Subject: University of Florida Training Reactor (UFTR) License Renewal (TAC NO. ME 1586),
DOCKET NO. 50-83

Enclosed is a revised Technical Specifications (TS) in support of our application for renewal of Facility Operating License No. R-56 for the University of Florida Training Reactor (UFTR). Enclosed is also a spreadsheet providing justification for the changes considered in the revised TS.

APPENDIX 14.1

TECHNICAL SPECIFICATIONS

Figure 6-1 UFTR Organizational Chart

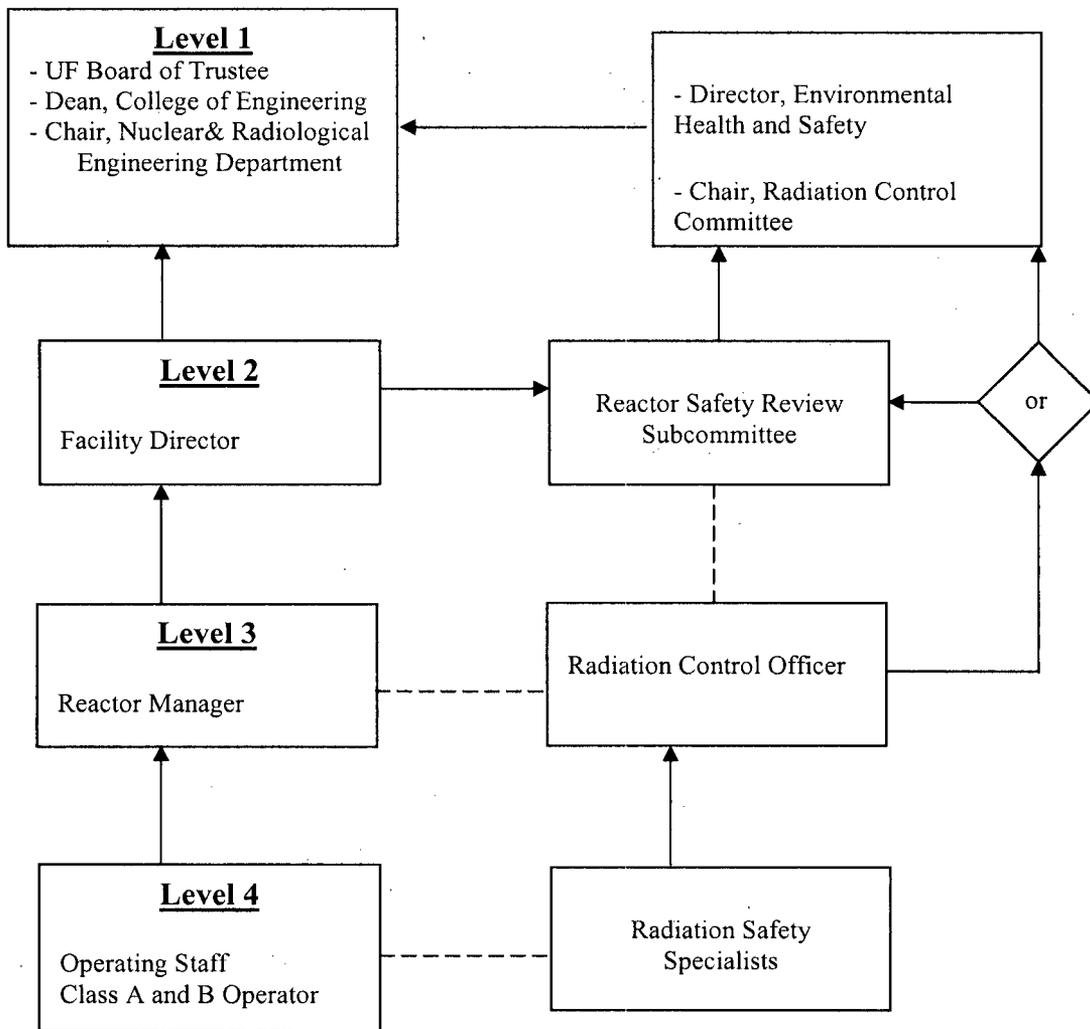
211	6.7.2.(3)c	6.6.2(3)c	C	Moved note out of parentheses for easy reading.
212	6.7.2.(3)d	6.6.2(3)d	C	units and inequality to remain consistent throughout specs
213		6.6.2(3)g	R	remove, redundant with all in section 6.6.2 and section 4
214	6.7.3(1)	6.6.3(1)	C	remove level 3, to remain consistent with ANSI 15.1
215	6.7.3(2)	6.6.3(2)	C	change end of sentence, assuming SAR and conversion report will be merged
216	6.8	6.7	C	Beginning of last sentence "Recorder charts" replaced with "Records", to clarify
217	6.8.1	6.7.1	C	(1) change time to 3 years to ensure NRC inspection cycle included for oversight, (3) additions made for clarity
218	6.8.2	6.7.2	C	Change to remain consistent with ANSI 15.1
219	6.8.3(4)	6.7.3(4)	C	replace "updated" with "current", clarify the statement
220	6.8.3(5)		A	Added (5) to remain consistent with new 6.8.1(3).
221	Figure 6.1	Figure 6.1	C	clean and clarify, no change in responsibilities
